UNITED STATES PATENT AND TRADEMARK OFFICE

APPLICATION NO.	FILING DATE	FIRST NAMED INVENTOR	ATTORNEY DOCKET NO.	CONFIRMATION NO.
10/712,286	11/12/2003	Robert J. Mills	14649	9293

Office Action Summary	Application No. 10/712,286	Applicant(s) MILLS ET AL.	
	Examiner Timothy M. Ayres	Art Unit 3637

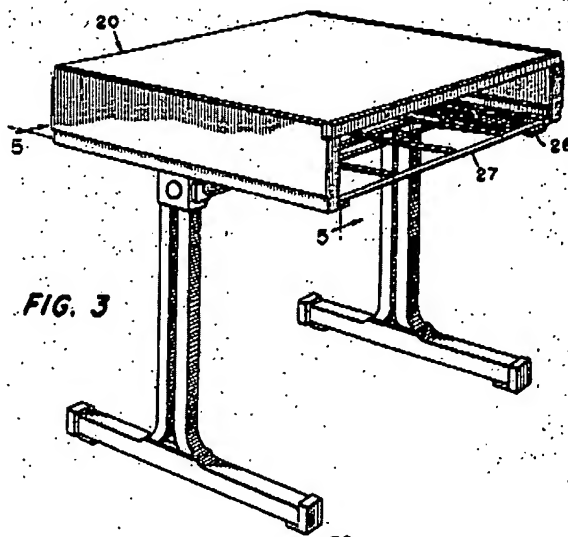
combination of figures 1, 2, and 3 clearly show these elements and should be described in the specification in greater detail to discuss these elements shown in the figures.

3. The drawings are objected to under 37 CFR 1.83(a). The drawings must show every feature of the invention specified in the claims. Therefore, the details of the first and second sections as shown in figures 1-3 must be labeled (following an updated description describing the elements as claimed) or the feature(s) should be canceled from the claim(s). No new matter should be entered.
